Groundwater Transfer Review Summary Form

Transfer/PA # T- 14848

Application: T-14848

Applicant Name: Buck Church/Church Hay Farm Inc

Application Map:

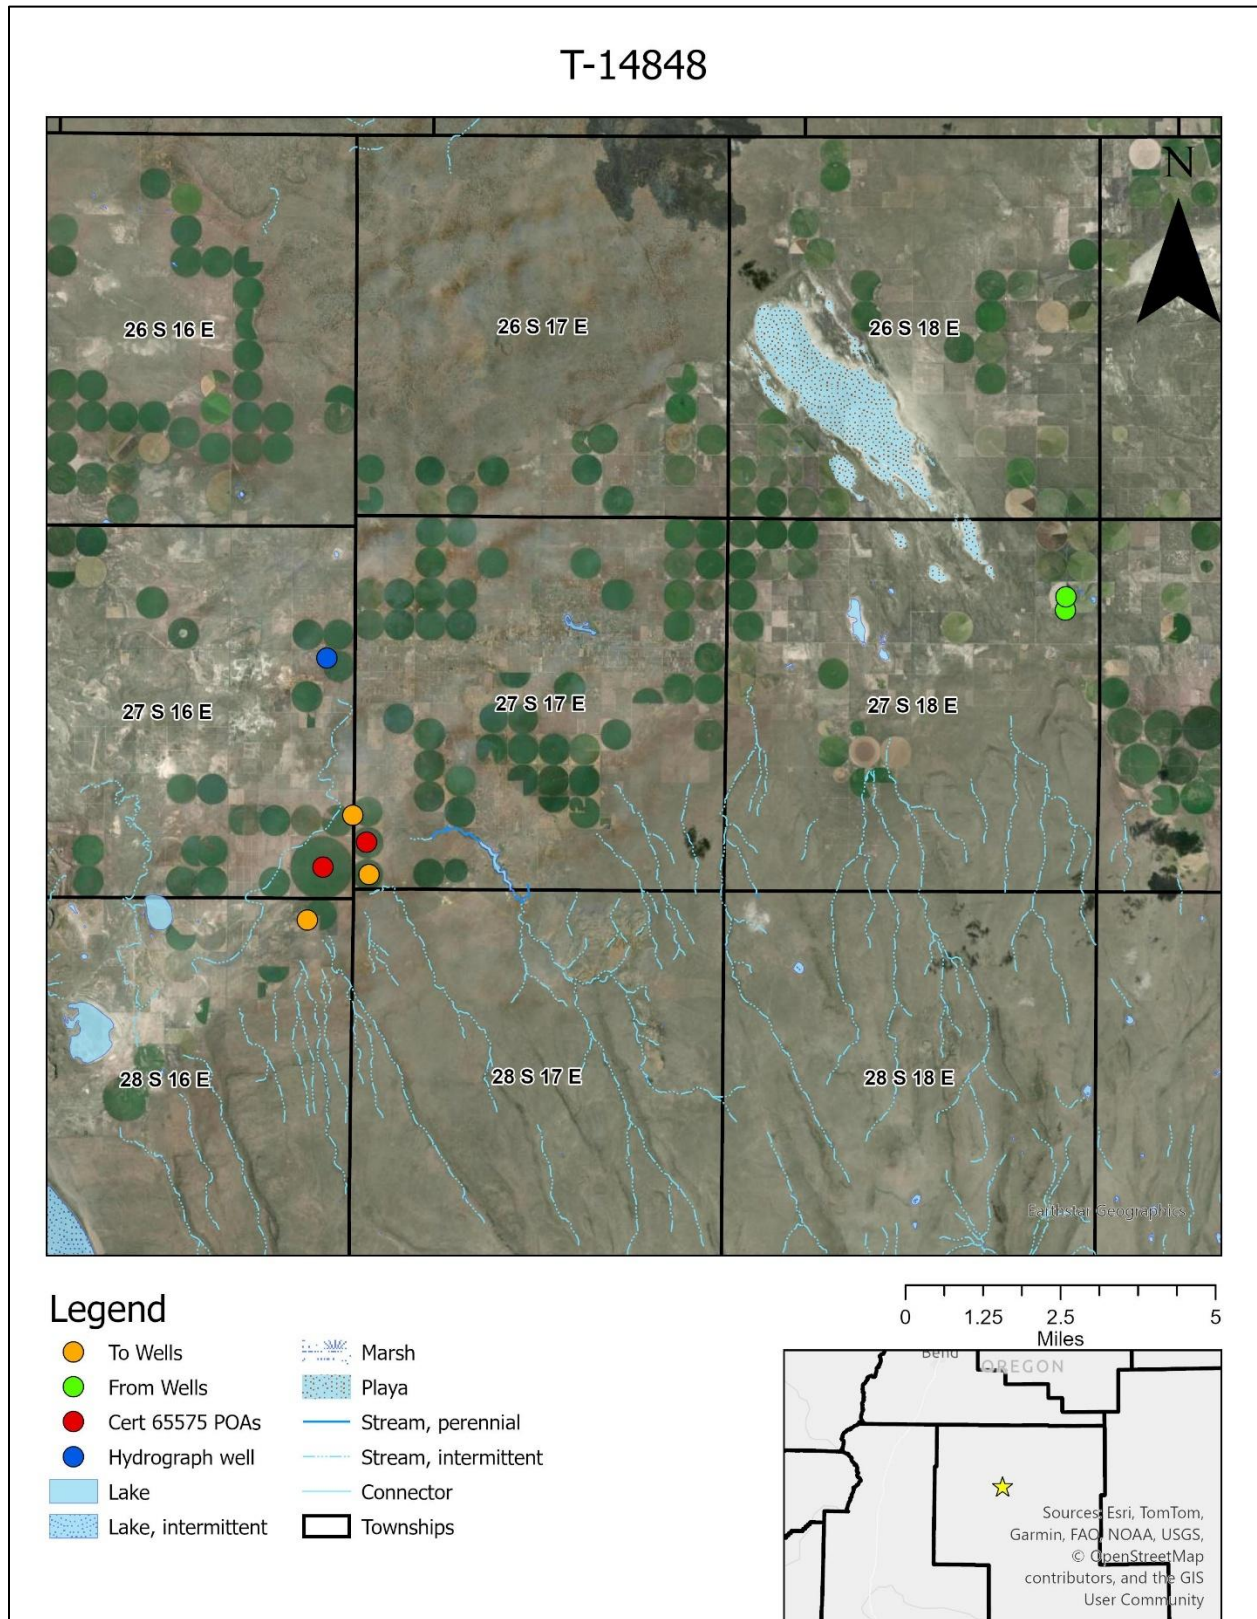
Water rights were purchased and proposed transfer will move POUs to complete 3 full circle pivots (22.1 acres in T28S/16E-S01, 20.6 acres in T27S/16E-S25, 10.8 acres in T27S/17E-S31).

Applicant is proposing to replace POA 1 with POA 8, POA 2 with POA 7, and add POA 5 as an APOA. A summary of POAs are listed in the table below.

Hydrograph showing water levels from proposed POAS, POAs from Certificate 65575, and nearby observation well (LAKE 874)

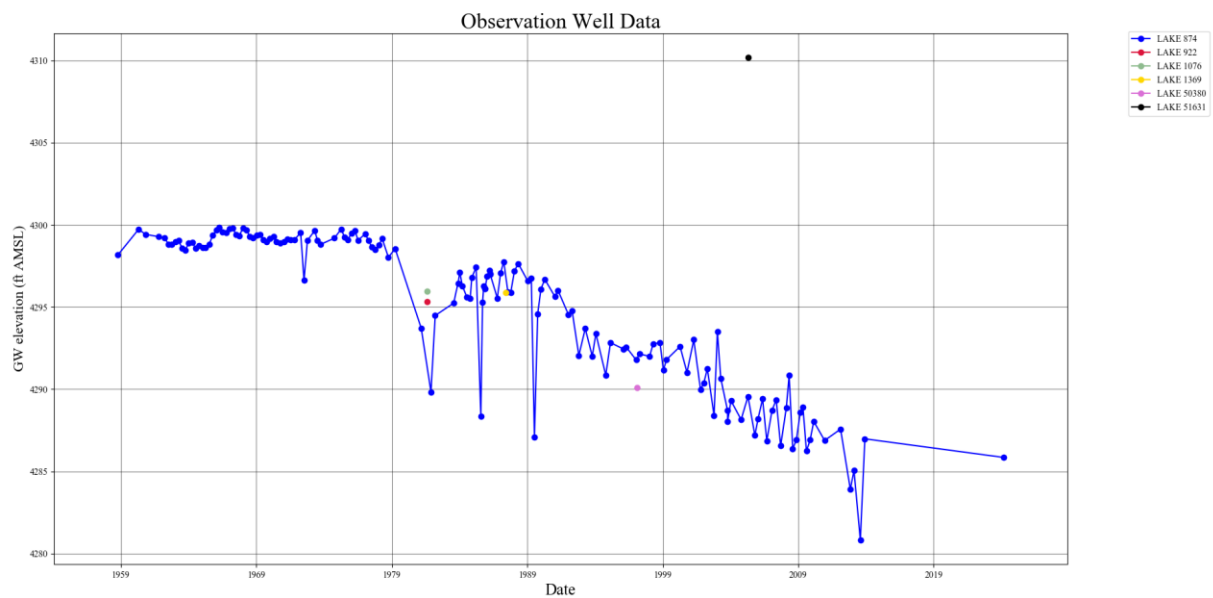
☐ Yes ☒ No If yes, explain: A Theis drawdown analysis was performed for this proposed change in POA using an intermediate storage coefficient of 0.001, transmissivity estimate of 15,000 ft²/day from McFarland and Ryals (1991), a combined maximum pumping rate of 0.67 CFS for a duration of 365 days from the proposed POAs, and maximum pumping rates of 1.67 and 6.41 CFS for a duration of 245 days from LAKE 1076 and LAKE 922, respectively. Using these parameters, the estimated increase in drawdown on LAKE 922 from the proposed POAs is 1.55 ft for a max drawdown of 73.62 ft. Recent measurements from a nearby observation well, LAKE 874, suggest that water levels in the area have declined and are responsive to pumping from nearby wells. However, the rate associated with this transfer is much lower than the rate of the affected nearby wells and the increase in drawdown would not meet the standard of "substantial or undue interference" as the wells associated with Certificate 65575 have enough depth to withstand estimated drawdown using conservative parameters. Screenshots of the Theis drawdown analysis and referenced hydrograph are included as attachments at the end of the review.

**Estimated drawdown from pumping of Certificate 65575 POAs**

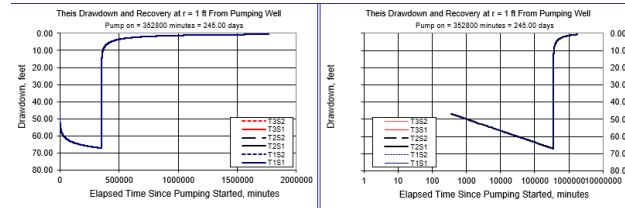
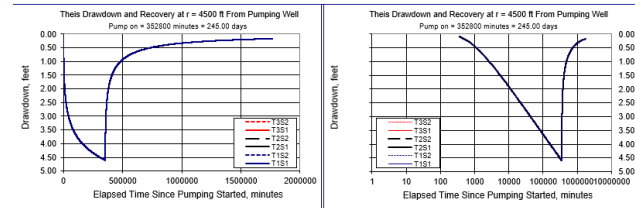
Since LAKE 922 has a larger max rate of 6.41 CFS, it will be used in the drawdown analysis in the following section.

**Estimated drawdown from pumping of T-14848 proposed POAS**

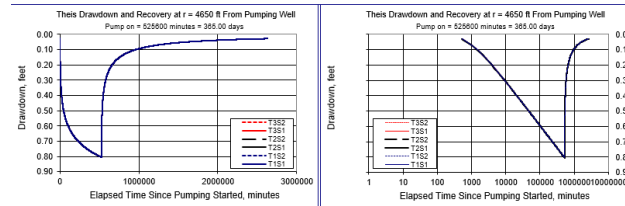
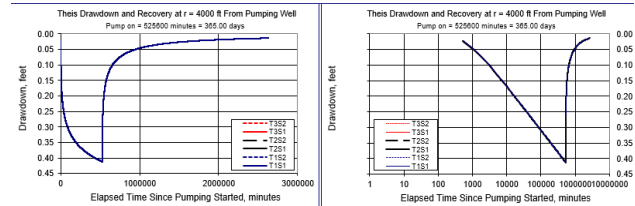
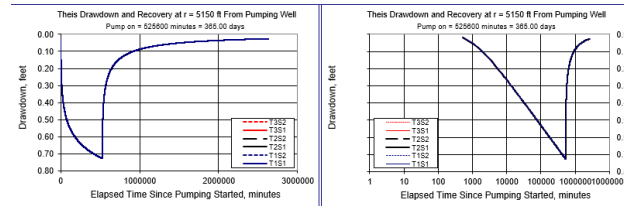
5. a) Will this proposed change, at its maximum allowed rate of use, likely result in an increase in interference with **another ground water right**?
☒ Yes ☐ No Comments: The proposed POAs are moving closer to the POAs for Cert 65575 (LAKE 1076 and LAKE 922). The original authorized well, LAKE 3102, is 63,000 ft from LAKE 1076 and is 67,500 ft from LAKE 922. This reduced distance should result in an increase in interference with the POAs for Certificate 65575. The table below shows the distance of each proposed POA to LAKE 922 as well as the estimated rate in CFS.
